Docket Item #15
BAR CASE #2005-0004

BAR Meeting
February 2, 2005

ISSUE: Alterations to previously approved plans

LOCATION: 510 North Columbus Street

Figure 1- Existing front 510 North Columbus Street (on right)

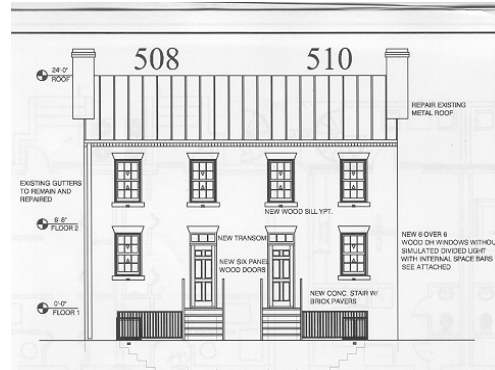
Staff has no objections to the alterations proposed for the front facade. As proposed, the front elevation is nearly identical to that approved by the Board on August 18, 2004 (BAR Case #2004-0068). Staff believes the alterations are appropriate and will improve the historic appearance of the house.

Figure 4 - 510 North Columbus proposed rear elevation (on right)

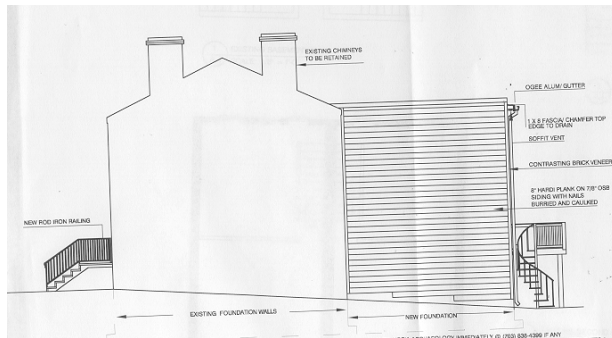
Staff is concerned by the large size of the addition, which represents an increase in the size of the existing house of nearly 72%. However, the proposed addition is similar in size to the addition on the neighboring house at 506 North Columbus Street and identical to the addition proposed for 508 Columbus Street. Moreover, the historic house and addition can not be viewed together. Lastly, Staff notes, the proposed addition is nearly 1' shorter than the addition that the Board approved for 510 Columbus Street on August 18, 2004.

The design of the addition is fairly routine. It uses traditional materials (wood and brick) and combines traditional features, like the six-over-six windows with more modern features like the rear deck and multi-light door and window unit. While the west facade is clad in brick, the brick will be different in color from that used for the historic building. This device is intended to distinguish the new construction from the old. Staff recommends that the north and west sides of the addition be clad in the same material, either fiber cement siding or brick. The use of siding on sides and brick on primary facades is a common convention in modern suburban residential construction and is not appropriate in the historic districts. The Board has adopted the following policy with respect to the product.

Therefore the use of fiber cement is appropriate on this modern addition, as long as the nails do not show in the installation, as is noted on the drawing, and as long as the siding is smooth.

Staff is somewhat concerned that the proposed addition side by side with that proposed for 510 North Columbus will read as one. However, as originally constructed, the entire row of eight apparently read as one, with only the pattern of doors communicating the individual nature of the houses. On the whole, Staff believes the proposed addition is acceptable and complies with the *Design Guidelines* for residential additions.

1. That the rear addition be clad either entirely in fiber cement or in brick;
2. That if fiber cement, that the fiber cement have a smooth, not wood grain, finish; and
3. That the following statement appears in the General Notes of the site plan so that on-site contractors are aware of the requirement:
Call Alexandria Archaeology immediately (703-838-4399) if any buried structural remains (wall foundations, wells, privies, cisterns, etc.) or concentrations of artifacts are discovered during development. Work must cease in the area of the discovery until a City archaeologist comes to the site and records the finds.
